UNITED STATES  
NUCLEAR REGULATORY COMMISSION  
WASHINGTON, D. C. 20555

SUBJECT: ST. LUCIE UNIT 1 - ISSUANCE OF AMENDMENT RE: SPENT FUEL POOL  
EXPANSION (TAC NO. 65589)

SAFETY EVALUATION  
BY THE OFFICE OF NUCLEAR REACTOR REGULATION  
RELATING TO THE RERACKING OF THE SPENT FUEL POOL  
AT THE ST. LUCIE PLANT, UNIT NO. 1  
AS RELATED TO AMENDMENT NO. 91 TO UNIT 1  
FACILITY OPERATING LICENSE NO. DPR-67  
FLORIDA POWER AND LIGHT COMPANY  
DOCKET NO. 50-335

**FIGURE 5.6-1**  
**INITIAL ENRICHMENT VS**  
**BURNUP REQUIREMENTS FOR STORAGE OF**  
**FUEL ASSEMBLIES IN REGION 2**

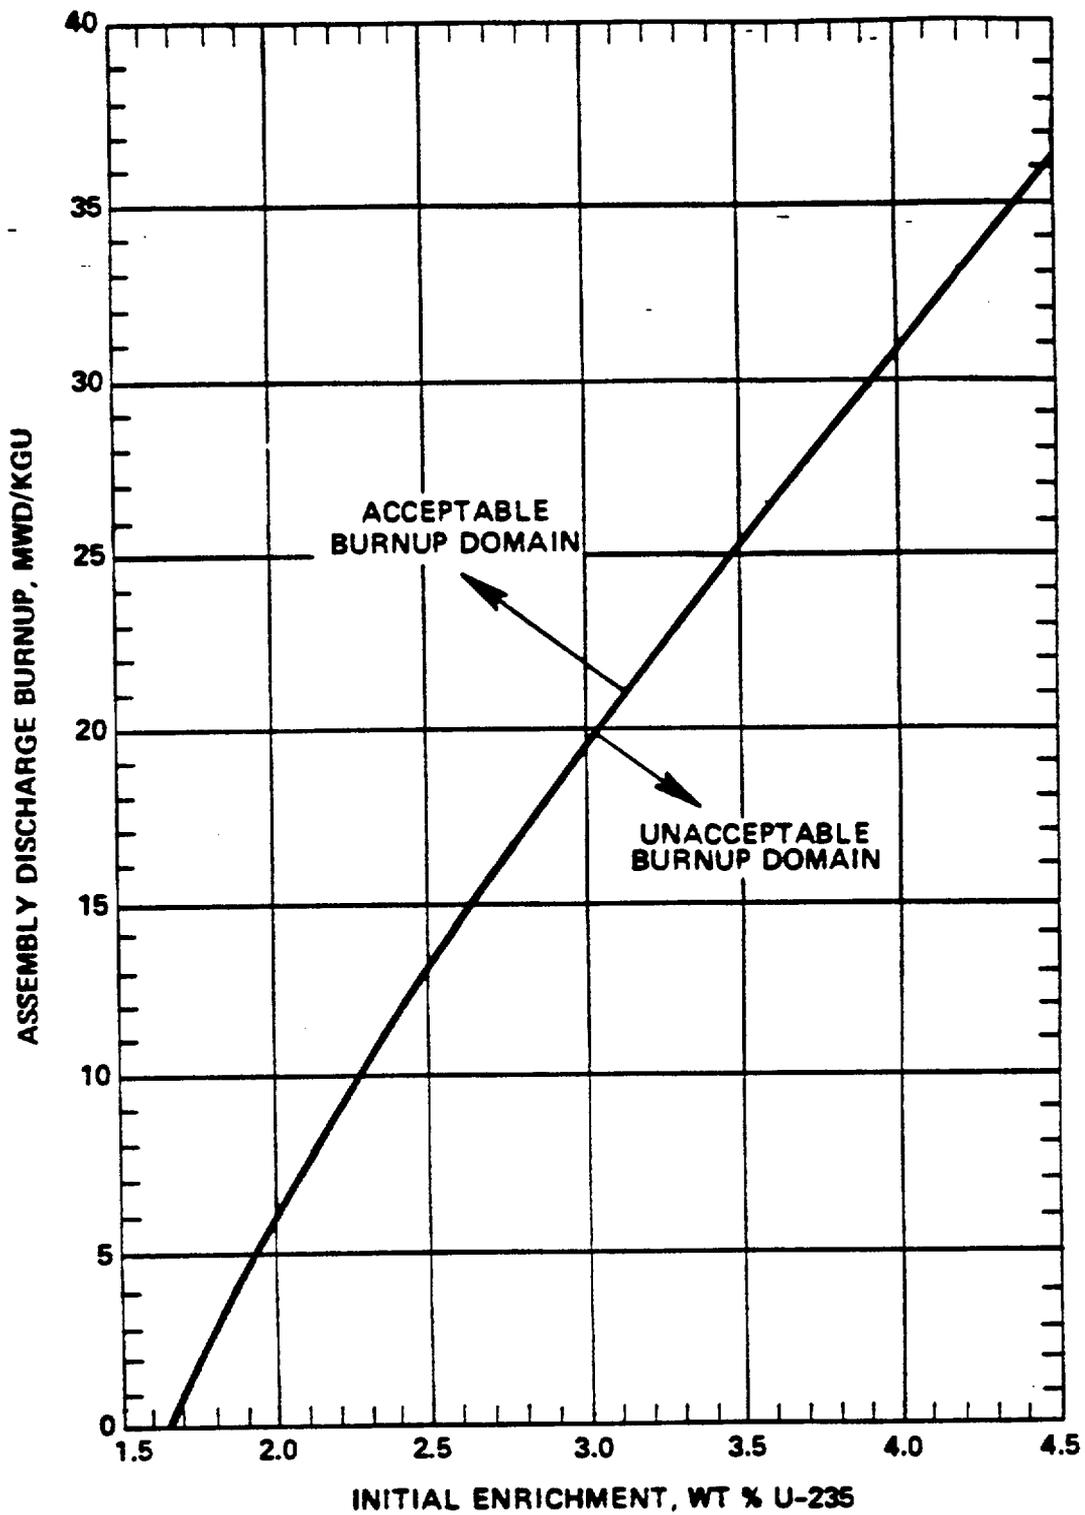
In order to calculate the criterion for acceptable burnup for storage in Region 2, calculations were made for fuel of several different initial enrichments. At each enrichment, a limiting reactivity value, which included an additional factor for uncertainty in the burnup analysis, was established. Burnup values that yielded the limiting reactivity values were then determined for each enrichment from which the acceptable burnup domain for storage in Region 2, as shown in proposed technical specification Figure 5.6-1, was obtained. The staff finds this procedure acceptable.

In the Region 2 analysis, the same uncertainties are considered, except there is no water gap and, hence, no gap thickness uncertainty. In addition, an uncertainty due to the burnup analysis is estimated and treated as an additive term in determining the burnup versus enrichment limiting reactivity values in Figure 5.6-1, rather than being combined statistically with the other uncertainties.

For Region 2, the rack multiplication factor is calculated to be 0.9435 for the most reactive irradiated fuel permitted to be stored in the racks; i.e., fuel with the minimum burnup permitted for each initial enrichment as shown in Figure 5.6-1. The design will accept fuel of 4.5 weight percent U-235 initial enrichment burned to 36.5 MWD/kgU of either the CE or ANF type from Units 1 and 2.

b. Region 1 of the spent fuel storage racks can be used to store fuel which has a U-235 enrichment less than or equal to 4.5 weight percent. Region 2 can be used to store fuel which has achieved sufficient burnup such that storage in Region 1 is not required. The initial enrichment vs. burnup requirements of Figure 5.6-1 shall be met prior to storage of fuel assemblies in Region 2. Freshly discharged fuel assemblies may be moved temporarily into Region 2 for purposes of fuel assembly inspection and/or repair, provided that the configuration is maintained in a checkerboard pattern (i.e., fuel assemblies and empty locations aligned diagonally). Following such inspection/repair activities, all such fuel assemblies shall be removed from Region 2 and the requirements of Figure 5.6-1 shall be met for fuel storage.

Based on the review described above, the staff finds the criticality aspects of the design of the St. Lucie Unit 1 spent fuel racks to be acceptable. The staff concludes that CE or ANF fuel from Unit 1 or Unit 2 may be safely stored in Region 1 provided that the enrichment does not exceed 4.5 weight percent U-235. Any of these fuel types may also be stored in Region 2 provided they meet the burnup and enrichment limits specified in Figure 5.6-1 of the St. Lucie Unit 1 TS.

FIGURE 1  
SPENT FUEL POOL LAYOUT

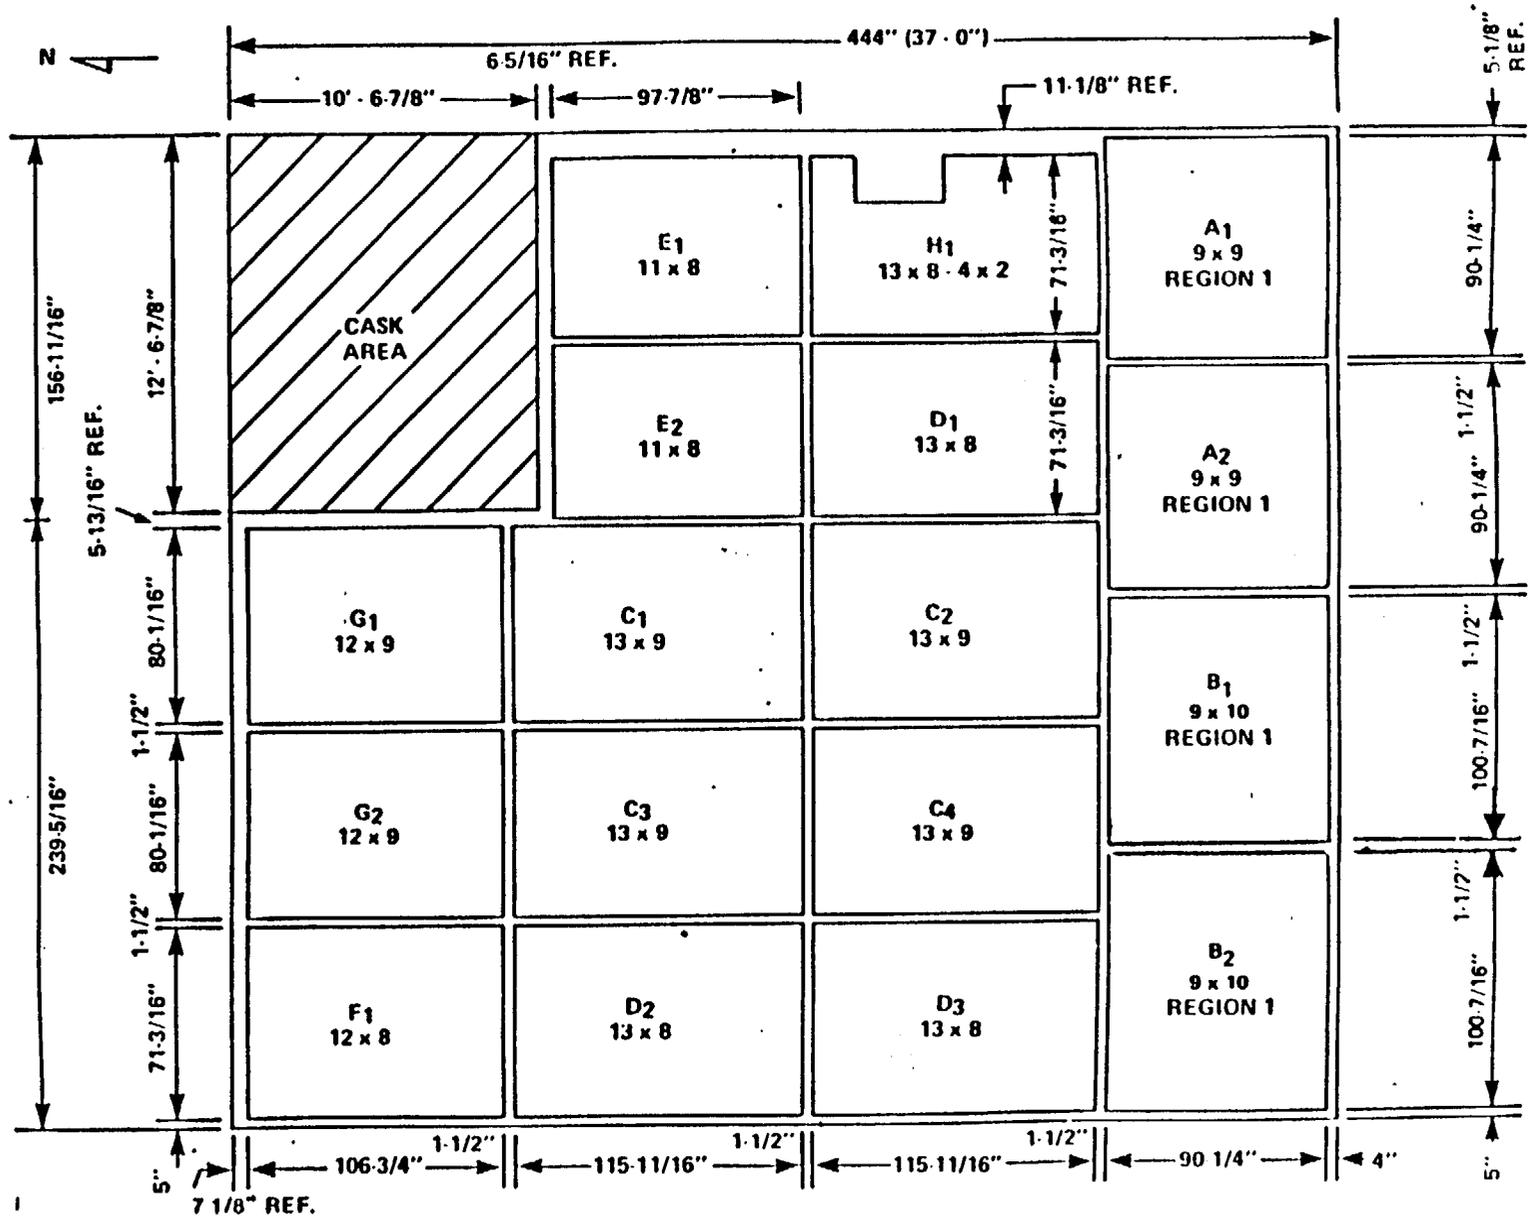
Rack modules B2, G1 and H1 (see Figure 1) were analyzed to show that structural integrity is maintained during a seismic event. The Licensee was asked to provide the basis for selection of these specific racks and gave the following information:

The four racks studied were racks A1, A2, B1 and B2, next to the south pool wall shown in Figure 1. A simplified planar two dimensional model of the row of racks was developed. Each rack was represented by a four degree of freedom model representing horizontal and vertical translations of the rack, planar rotation (rocking) of the rack, and horizontal translation (rattling) of the fuel assemblies. The racks were assumed to be fully loaded with fuel using the nominal fuel weight (1250 lb/assembly) which is half the weight used in the single rack design basis models. Support spring constants, impact spring constants and gaps were consistent with the design basis models. Fuel to cell fluid coupling coefficients were reduced to 50% of the "blunt body" value in an attempt to compensate for the potential overprediction of fluid coupling forces predicted by the design basis models as discussed in Section 4.1.2. Runs were made for both the 0.2 and 0.8 coefficients of friction. The seismic loading of the E-W and vertical SSE were applied simultaneously to the model.

FIGURE 8  
 ADJUSTABLE SUPPORT LEG

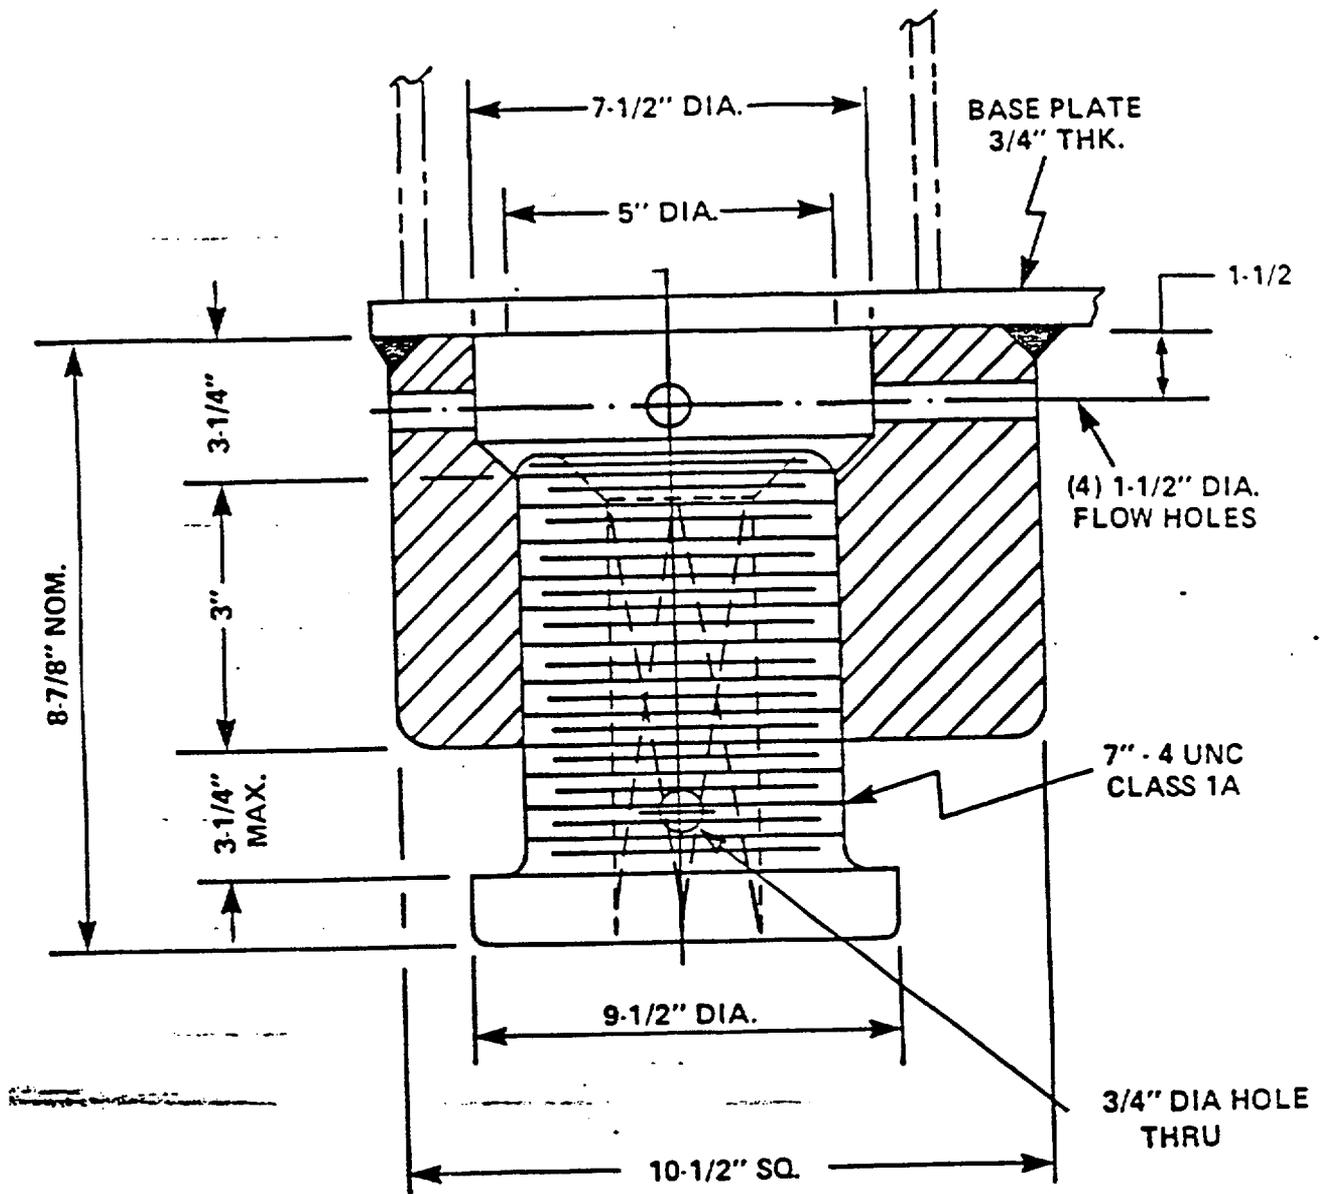
Each module has at least four support legs. All supports are adjustable in length to enable leveling of the rack. The variable height support assembly consists of a flat-footed spindle which rides into an internally-threaded cylindrical member. The cylindrical member is attached to the underside of the baseplate through fillet and partial penetration welds. Figure 8 shows a vertical cross-section of the adjustable support assembly.
